Attachment A. Interference Analysis of MDSA Transmitter

EPFD Levels and Contours of MDSA Proposed Experiment

Figure 1 shows the actual PFD contours of the MDSA antenna described in the supplement.

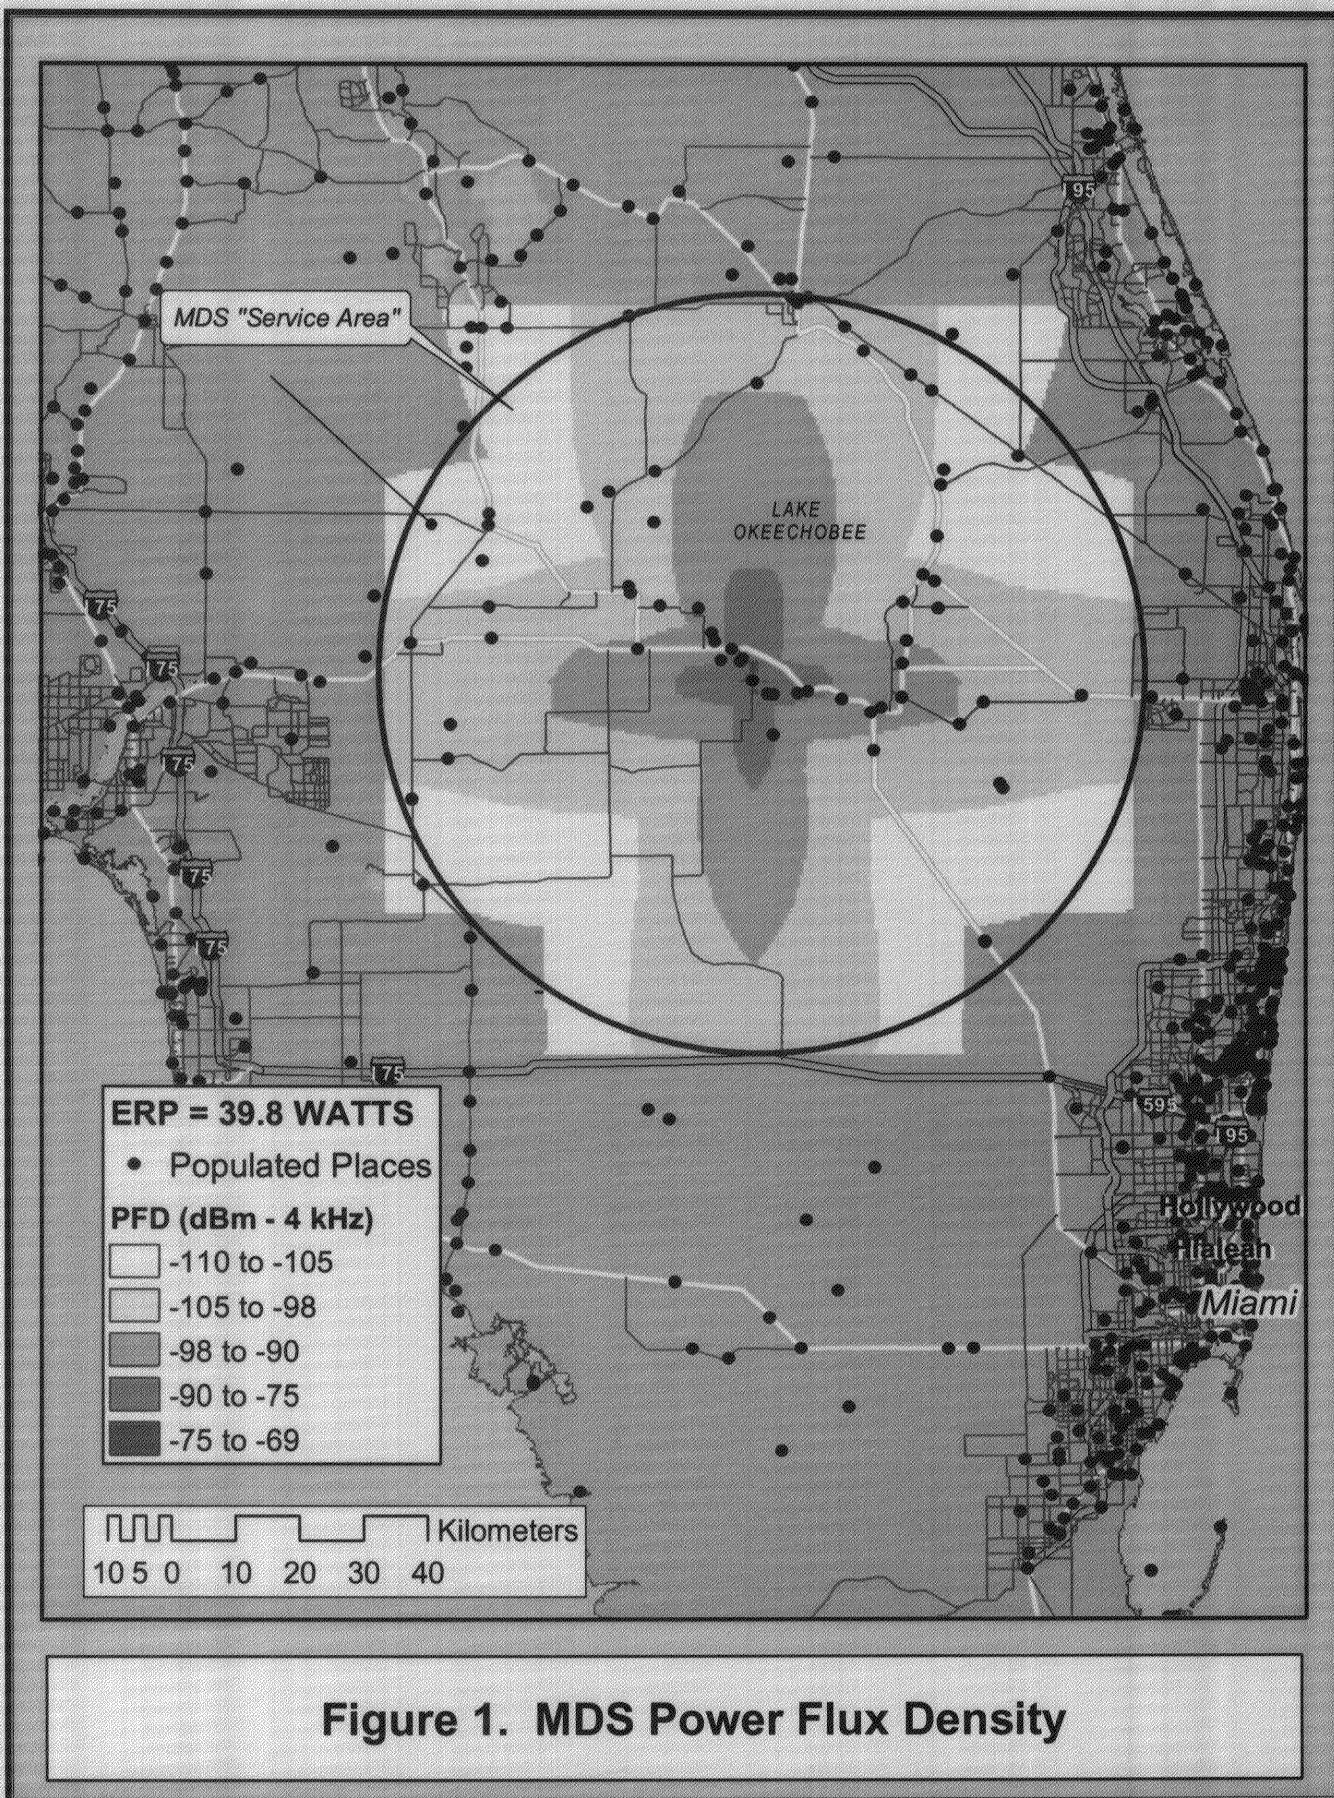
MDSA presented a series of round PFD contours in its supplement, but the MDSA antenna has variable gain with azimuth, up to 12 dB; therefore the actual PFD contours are not round, but clover-shaped. Moreover, MDSA did not identify the bandwidth associated with its PFD contours, but in any case, as the following table illustrates, MDSA's contours cannot be rectified with free space propagation.

Figure 2. MDS Would Exceed EPFD Levels Over a Huge Populated Area

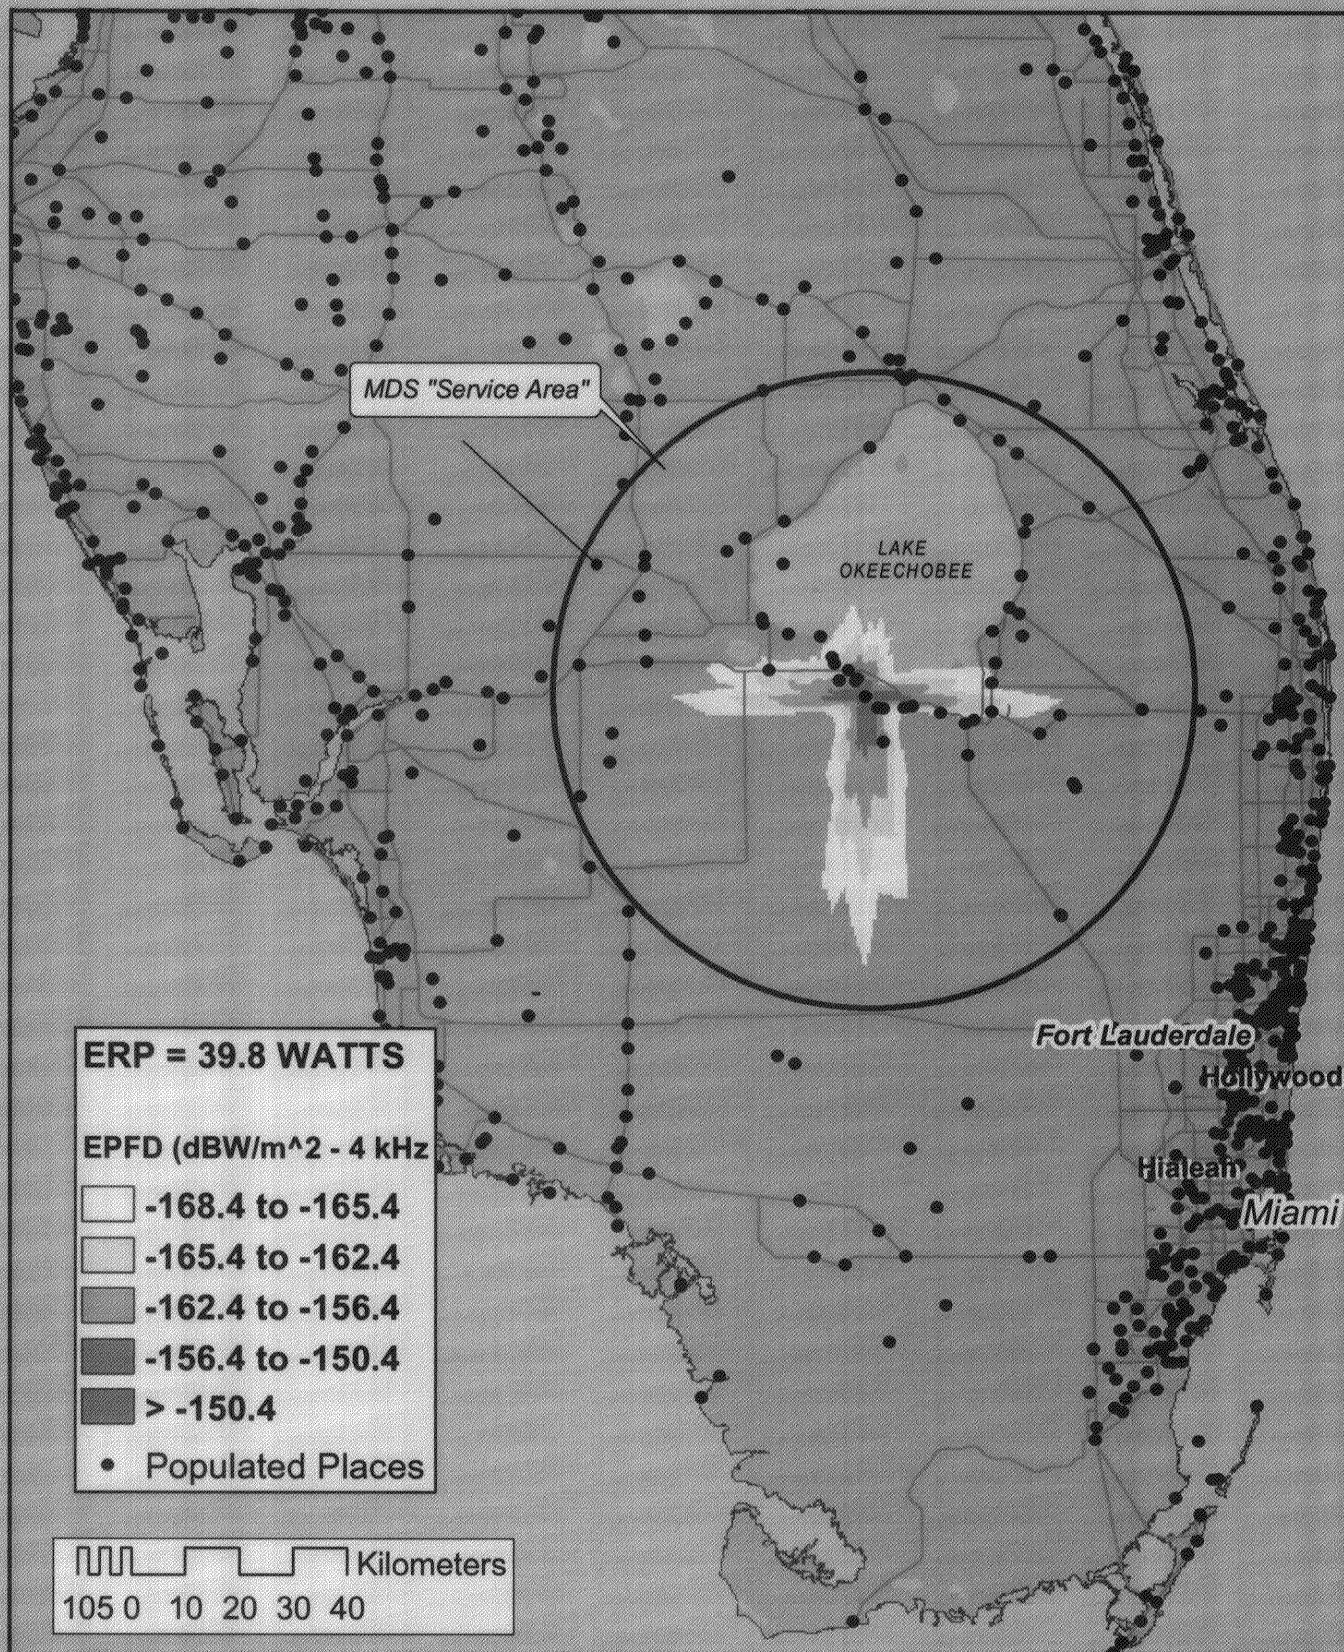
Figure 2 shows the allowable EPFD of -168 dBW/m² – 4kHz would be exceeded in a large, populated portion of the MDSA proposed “service area”.

From these figures it is clear the MDS proposed experiment certainly would exceed the FCC EPFD contours for a large populated area and would cause harmful interference to any unprotected DBS operation. The analysis shows that more than ten thousand of residents of Clewiston, Florida and the surrounding area would be within the EPFD contours, as shown in the following table. Over 3,000 persons would be within the contour where the EPFD is exceeded by over 12 dB.

Figure 3. MDS Transmissions Likely to Cause Outage in Clear Air for Highly Populated Area

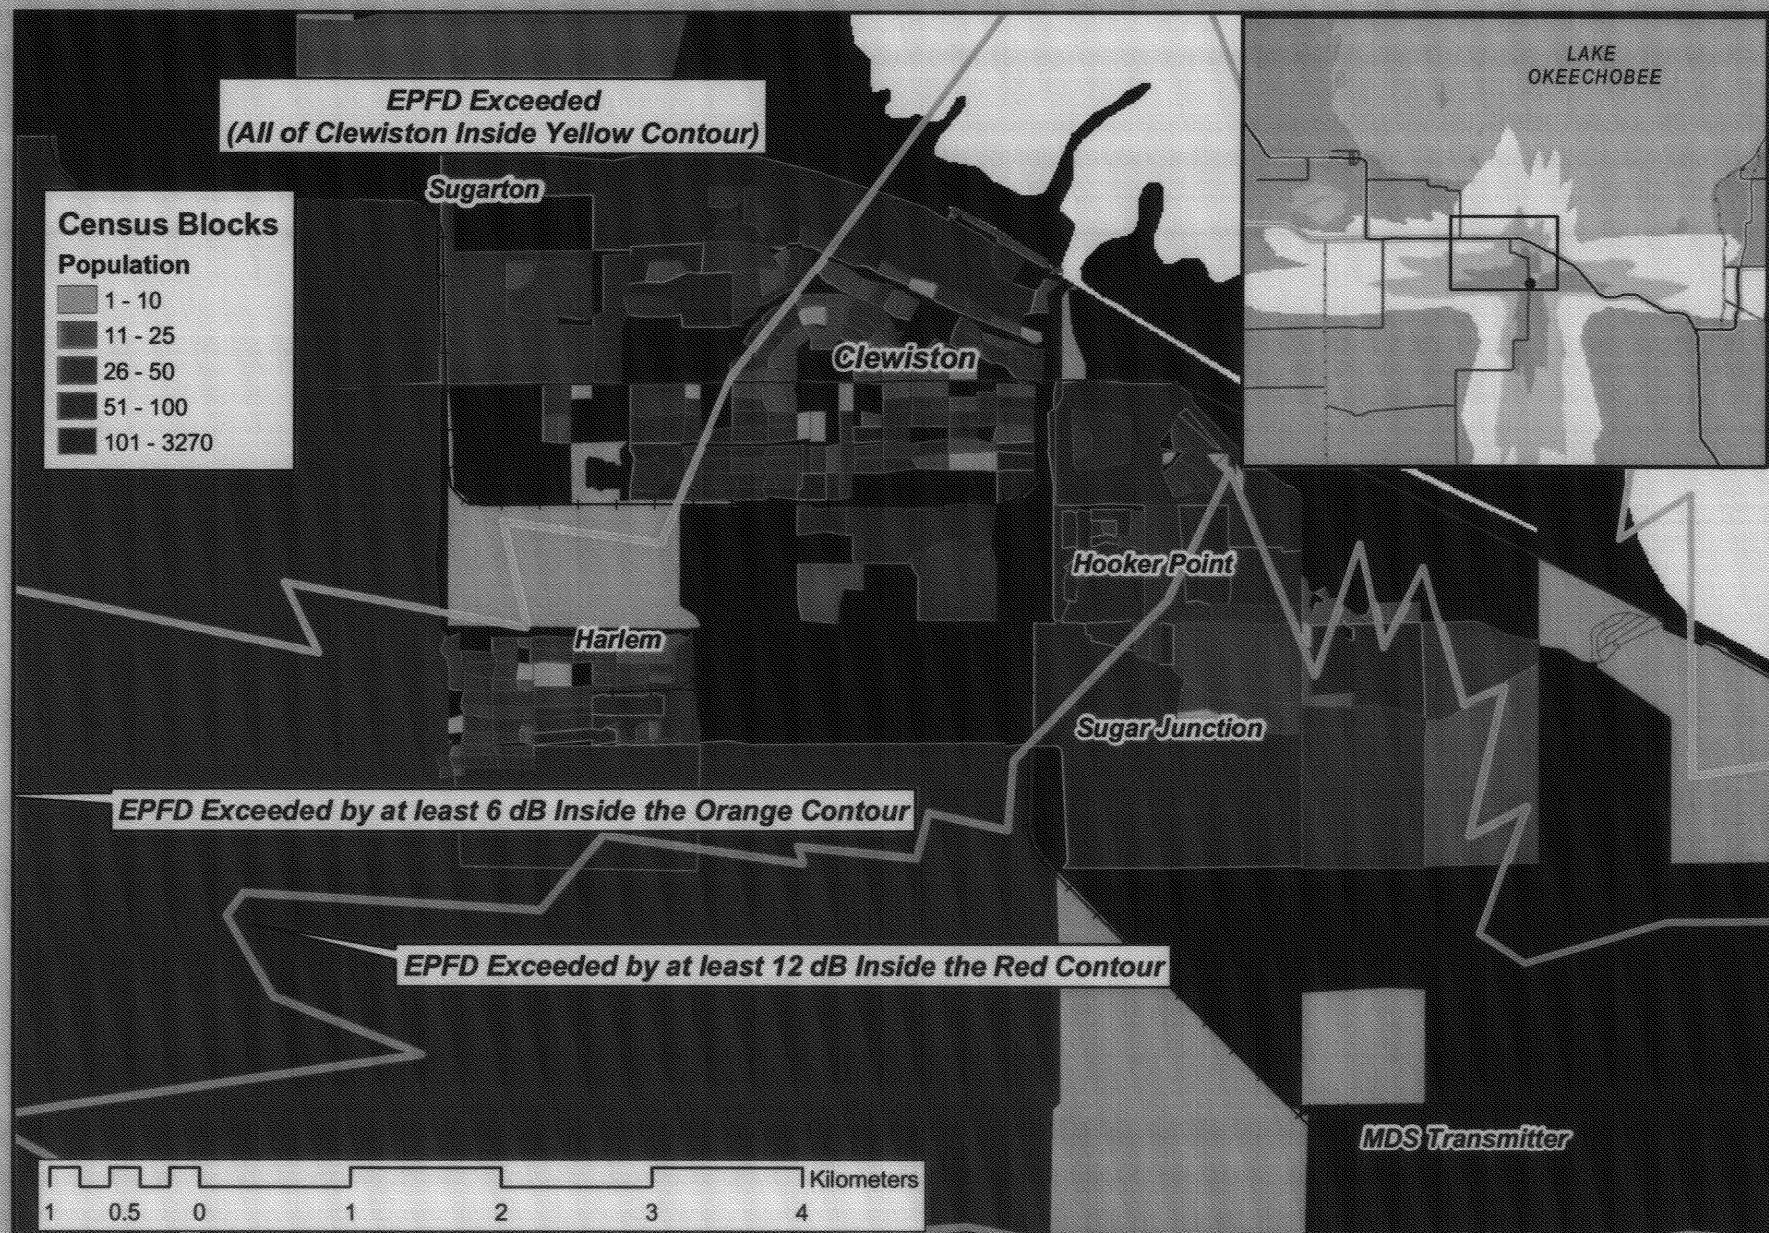
Figure 3 shows the area near Clewiston where the EPFD would be exceeded, along with the year 2000 Census blocks.
